## ARTWORK TEMPLATE

10 LITRE - TAPERED PAIL 276(D) x 205(H)

STANDARD No. PB-276-D-205c-1
Manu Stand No.: PS-1-44
AUTH BY: K.W.

## FLAT LAYOUT

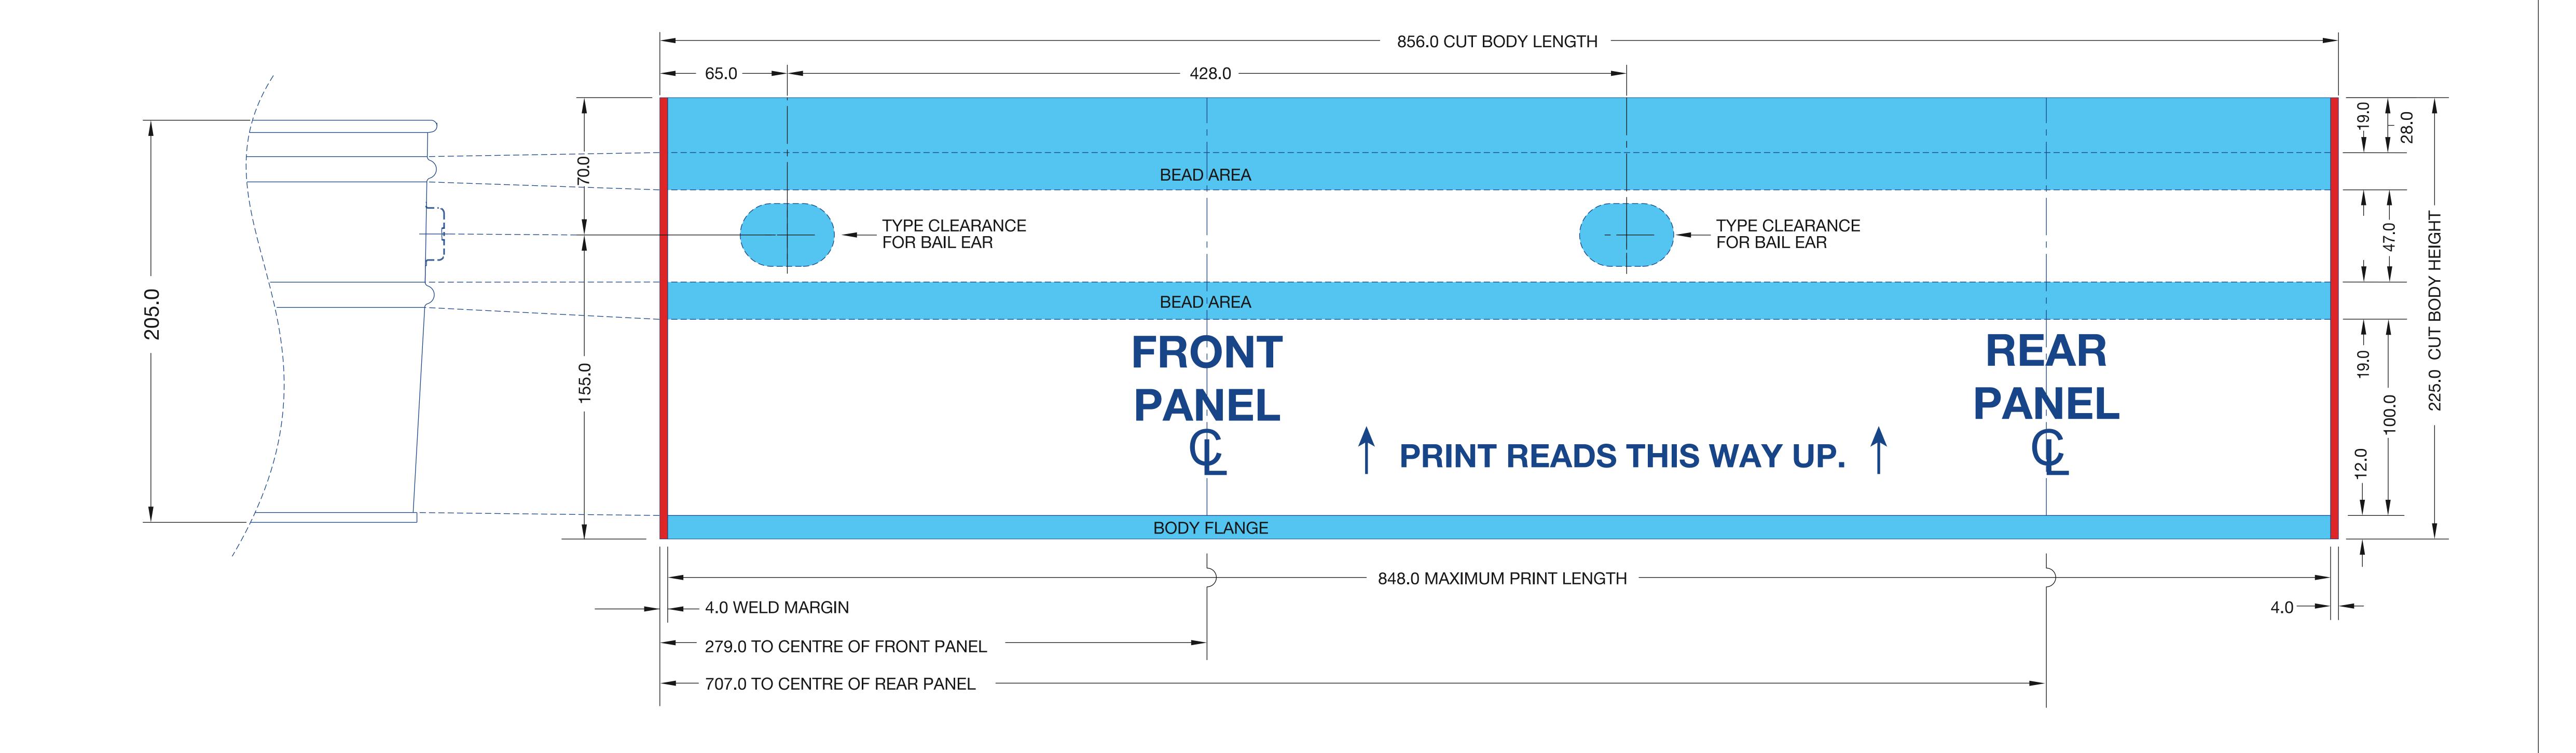
DATE:	REVISIONS:	
7/02/09	Add ±8 Tolerance to bail ear position

NOTE: Bail ear position can vary ±8.0mm around the circumference of the pail. Do not line graphic elements up to bail ears.
